June 28, 2016

**Re: Notice of Minor Proposed Alteration
Licence and Minor Clause Change
Rice Lake Gold Mine - Environment Act Licence 2628RR
Klondex Canada Ltd.**

Attachment 3

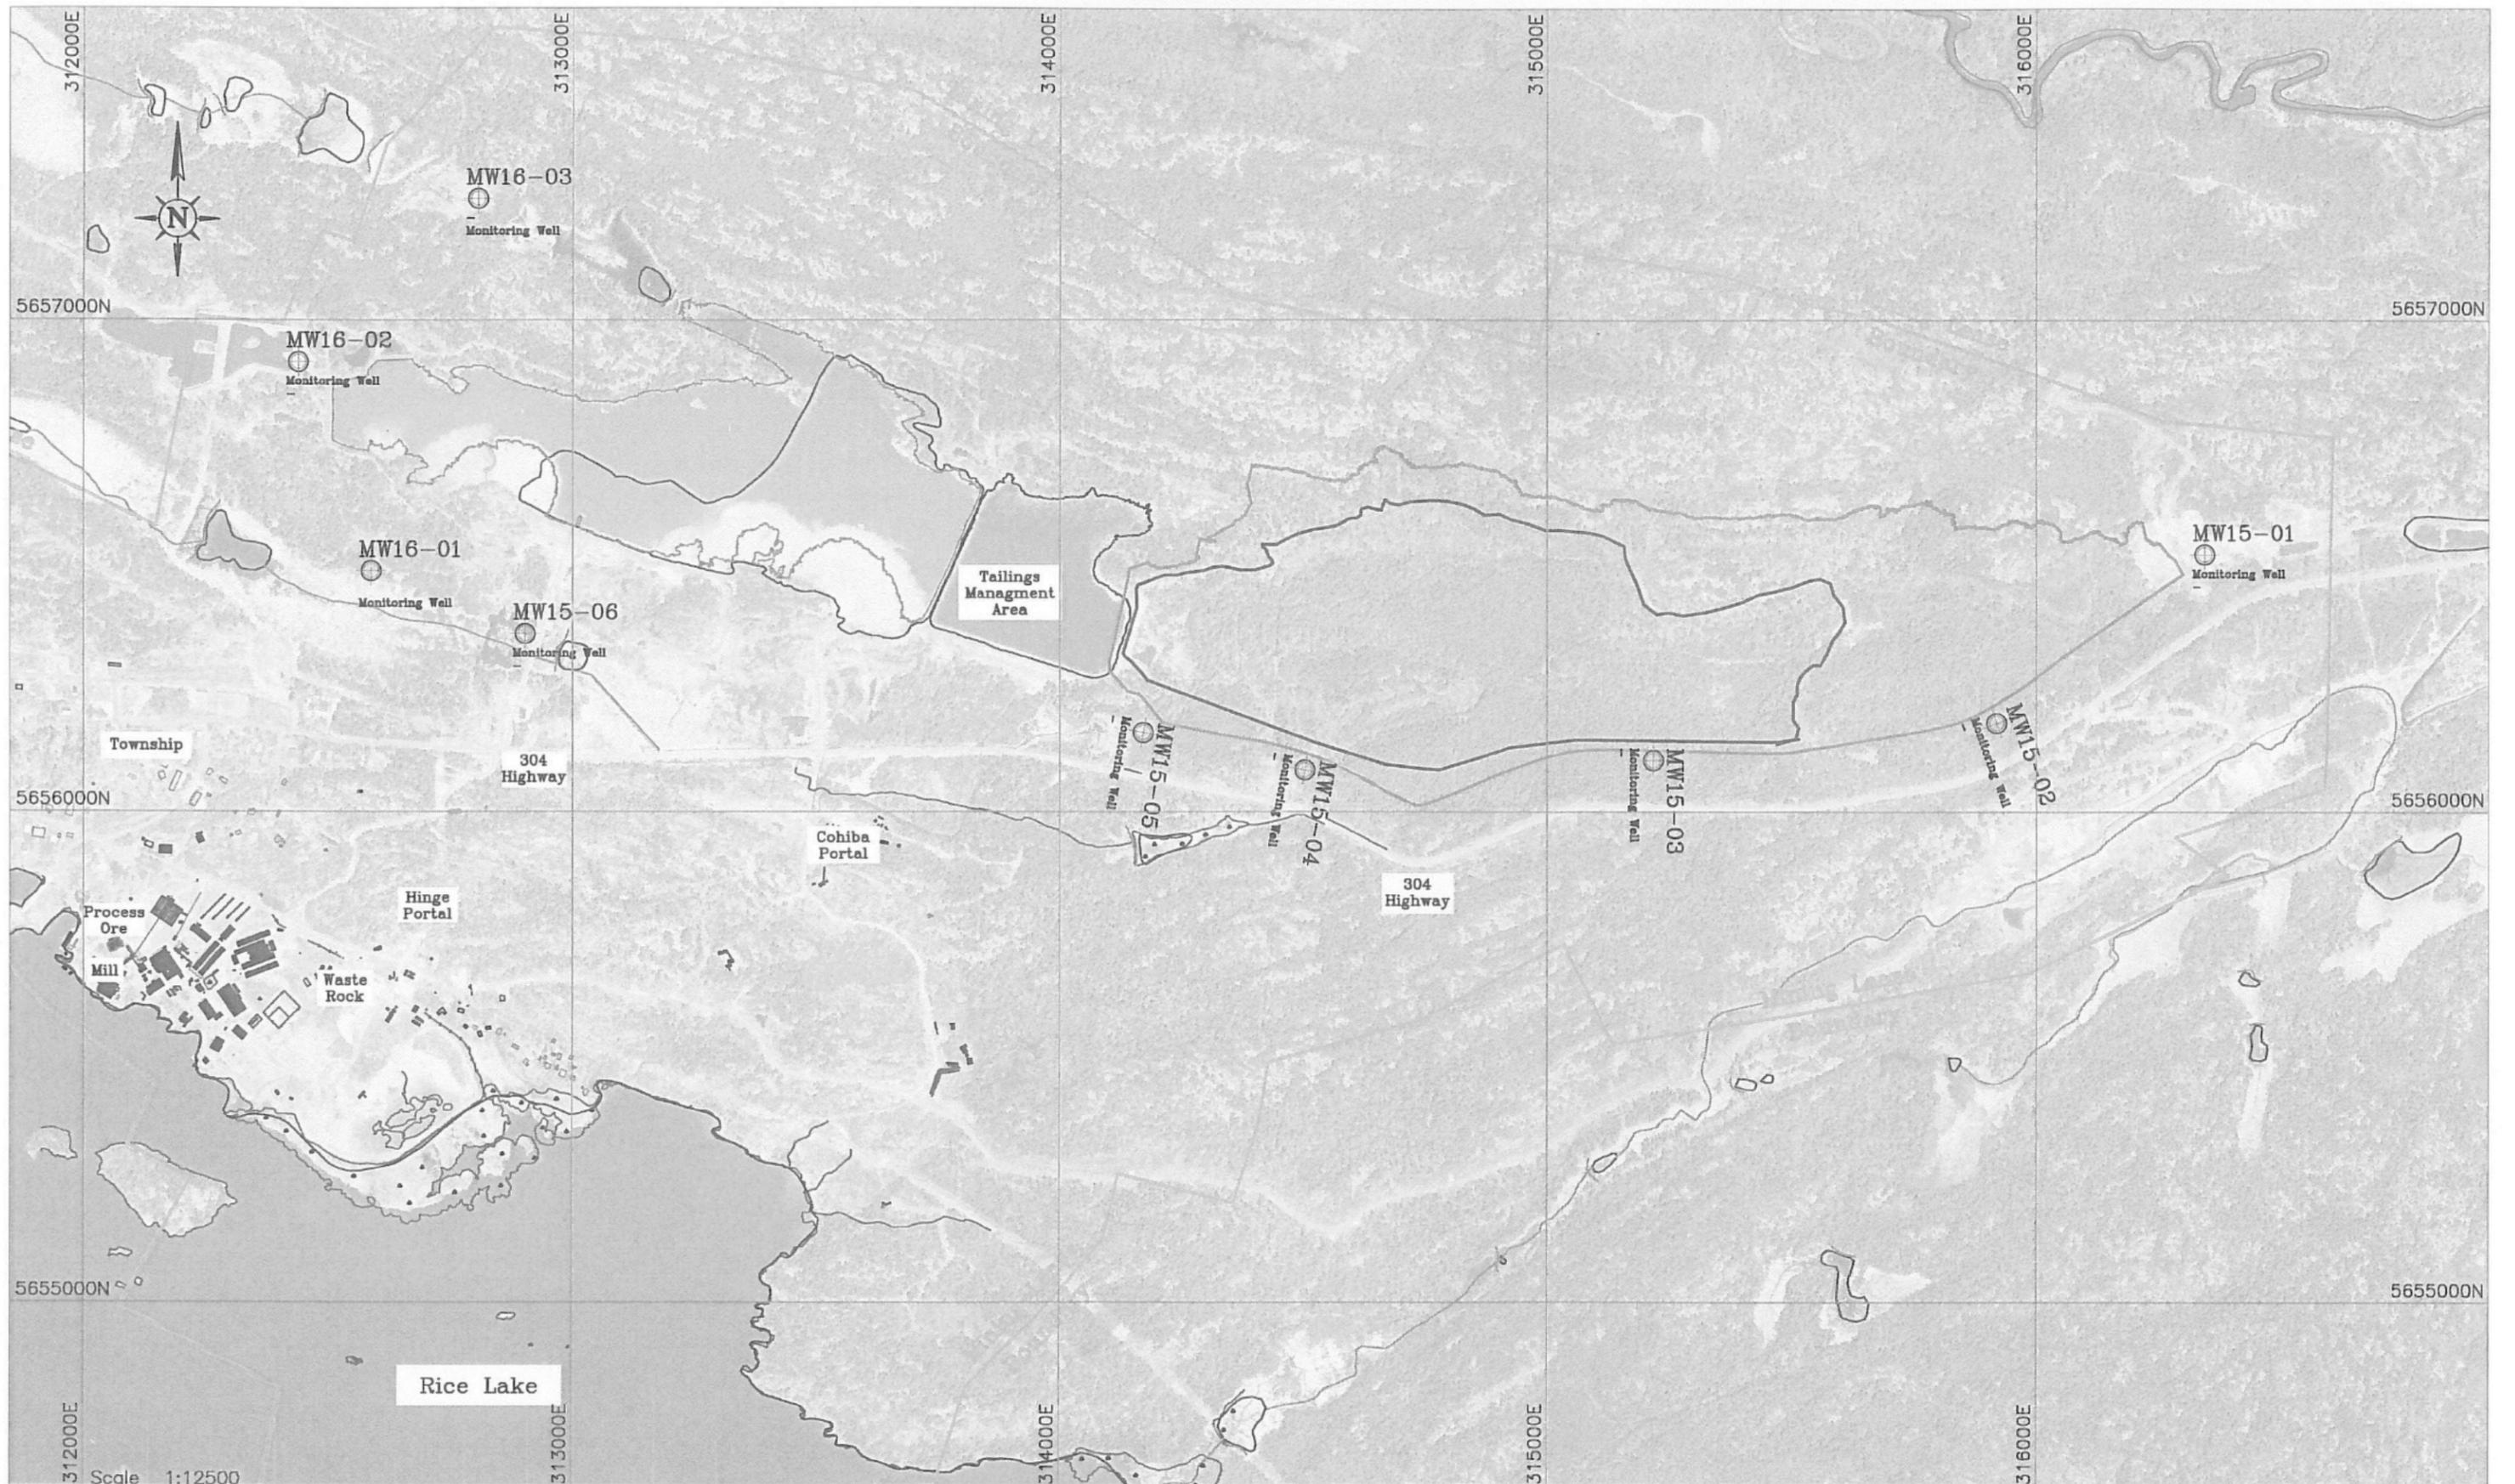
The groundwater monitoring well system has been upgraded as outlined in the *2015 Annual Groundwater Monitoring Report* submitted to the Branch on May 12, 2016 and AECOM letter reports dated November 4, 2015 and March 31, 2016. Klondex is proposing the groundwater monitoring wells be designated as:

MW15-01
MW15-02
MW15-03
MW15-04
MW15-05
MW 15-06
MW 16-01
MW 16-02
MW 16-03

The location of these groundwater monitoring wells is shown on Attachment 3.
